MEMORANDUM

Subject: Rezoning, Preliminary and Final Development Plans, Preliminary and Final Plat,
Platting Variance to defer Park Dedication Fees, and Conditional Use Permit for the
Sick Technology Campus

Kimley-Horn has reviewed the comments provided by the City of Bloomington dated February 16, 2021 and has modified the plans accordingly. The comments and responses are listed below. Responses to comments are in ***bold italics***.

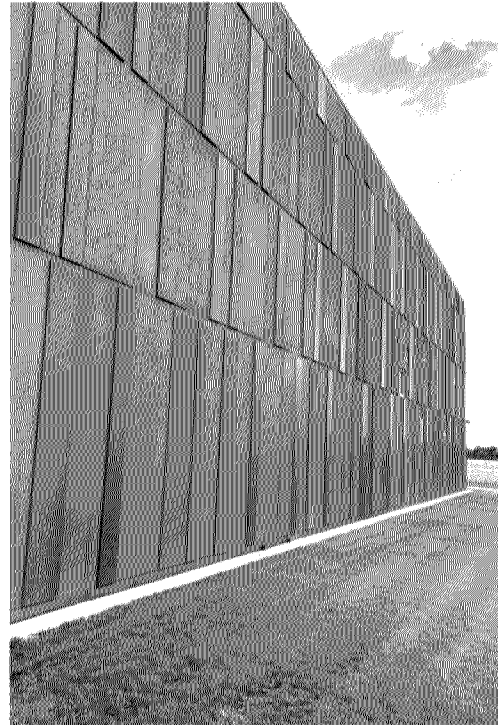
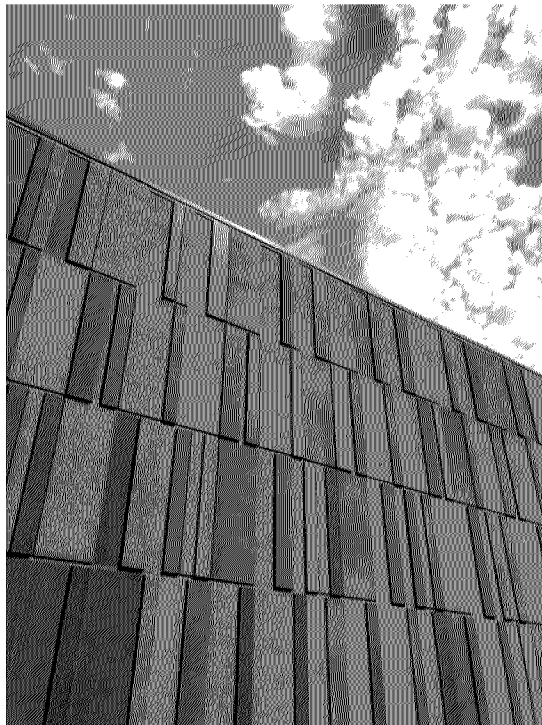
11. Exterior materials must meet Section 19.63.08. The proposed materials, pre-cast architectural concrete panels require a deviation from City Code. Please provide additional detail on the proposed panels.

The precast architectural concrete panels being proposed are a combination of acid-etched, polished and sandblasted charcoal grey/black concrete, in combination with Structurally Glazed (butt glazed) curtain wall systems. The precast concrete is a high-quality and durable finish in keeping with the standards of the City of Bloomington for developments in this area. Large portions of the concrete will be polished to a reflective finish resembling polished granite. See image below from a completed project with similar finishes.
